CONSULTING PARTIES PRESENTATION

THE WHITE HOUSE VISITOR SCREENING FACILITY PROJECT

CFA COMMENTS FROM 03/19/2026 CONCEPT SUBMISSION

SECTION SHOWING VIEW THROUGH ABOVE-GRADE SCREENING AND CLEARED VISITOR EGRESS

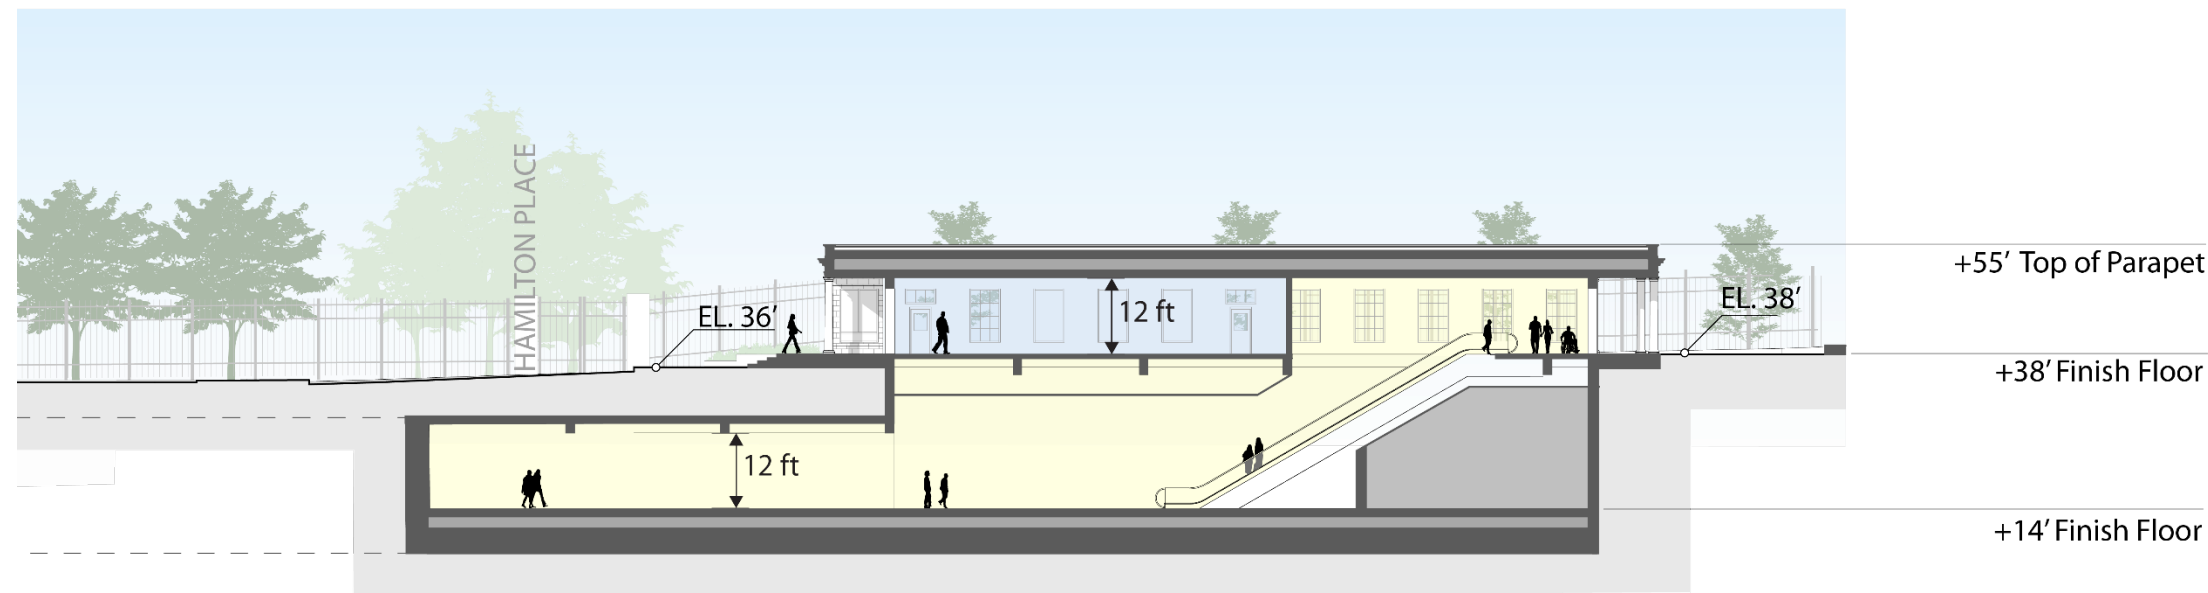
CFA Comment 3/19/2026 -
Reduce size of exit building:

- Flattened roof and reduced overall height of parapet to 17'-0" to accommodate the minimum height needed for 12'-0" clear at screening equipment and 13'-10" elevator overrun.
- Overall building length is being reviewed and will be reduced if security screening equipment requirements are met.
- Evaluated with civil design to locate building at finished floor elevation 36'-0". Adjacent road contours pose many challenges. The building as designed is shown at 38'-0" FFE with an integrated granite base, steps, and ramp.

ELEVATIONS OF EXIT STRUCTURE ON EAST EXECUTIVE AVENUE

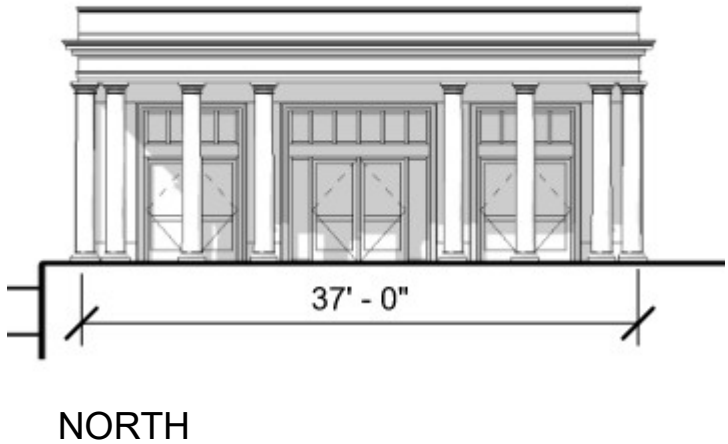
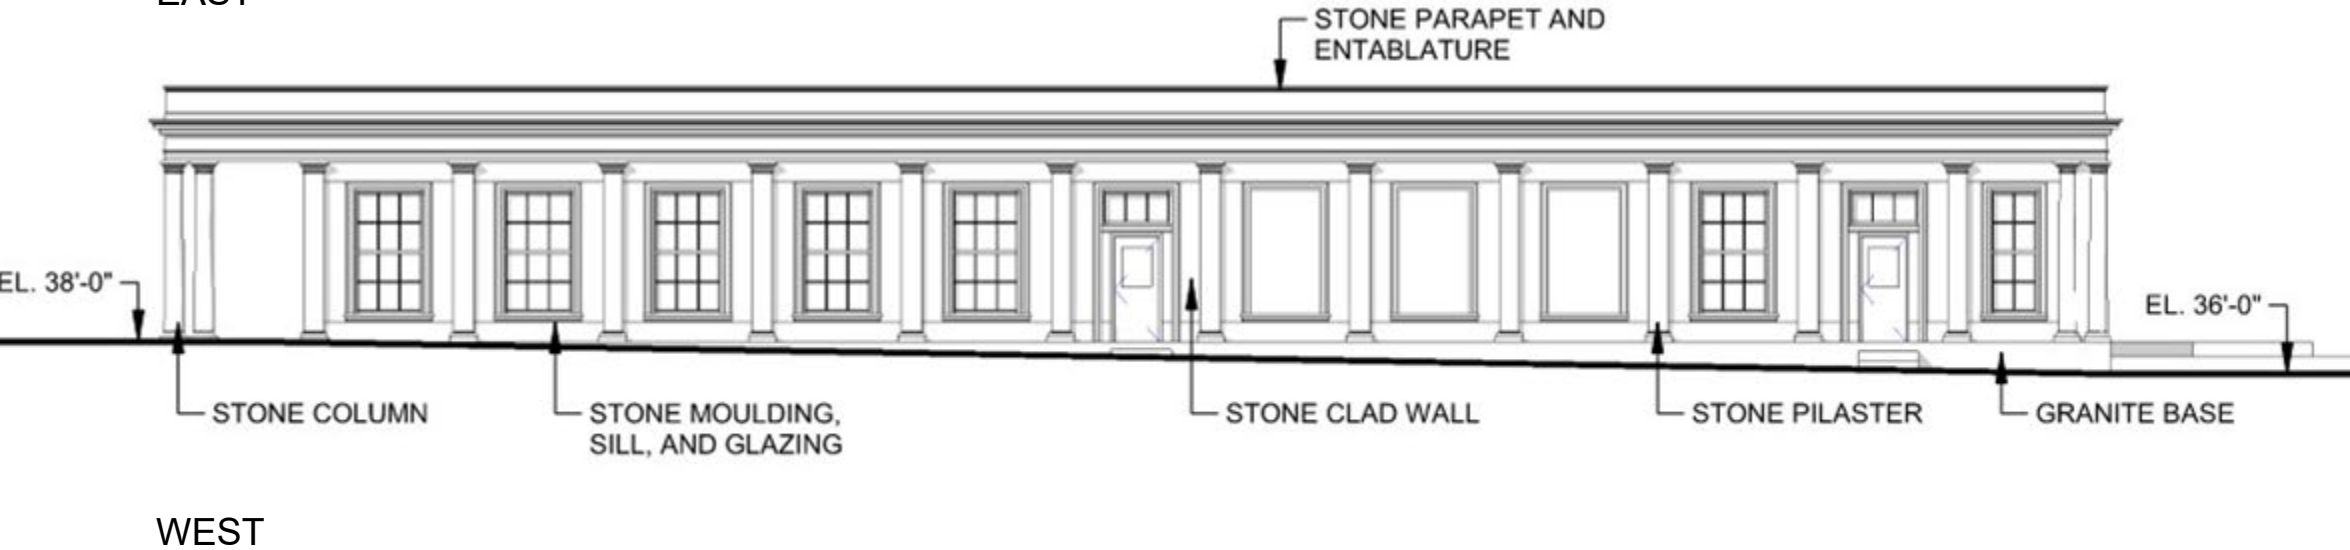
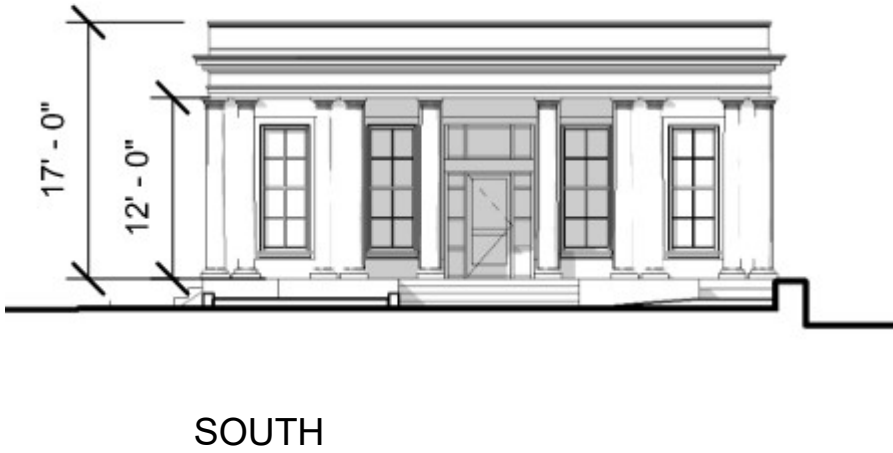
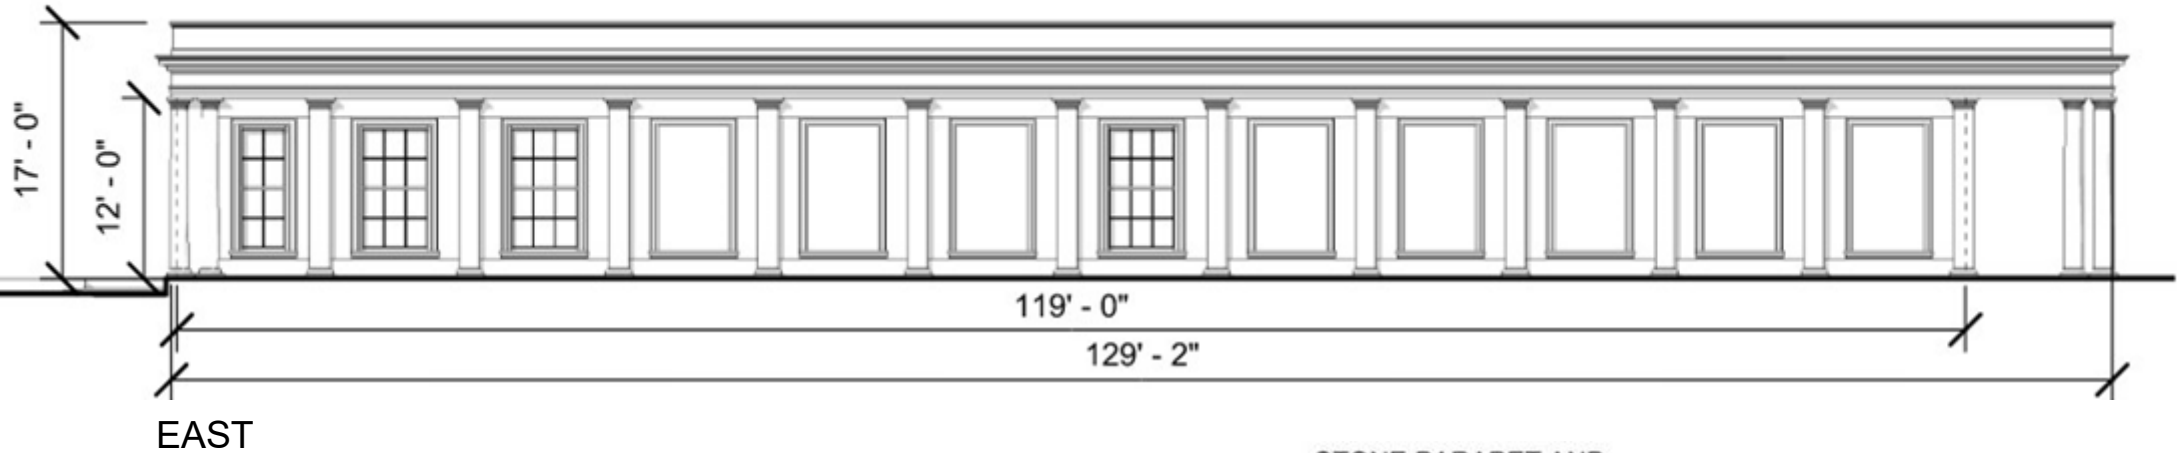
CFA Comment 3/19/2026 -
Review design to incorporate Executive Order on
Architecture:

Exit Building / Staff Screening:

- Coupled columns on the north and south facades to define entries (shown as Doric order similar to site adjacent West Wing entrance, E/W colonnades, and previous East Wing).
- The building composition incorporates a flat roof with a classically ornate entablature and parapet with stone cladding and granite base.
- Pilasters run along the east and west facades in a regular rhythm with glazing integrated where possible or solid infill within frame.
- Glazing systems will incorporate traditional moldings and trim in alignment with classical design.
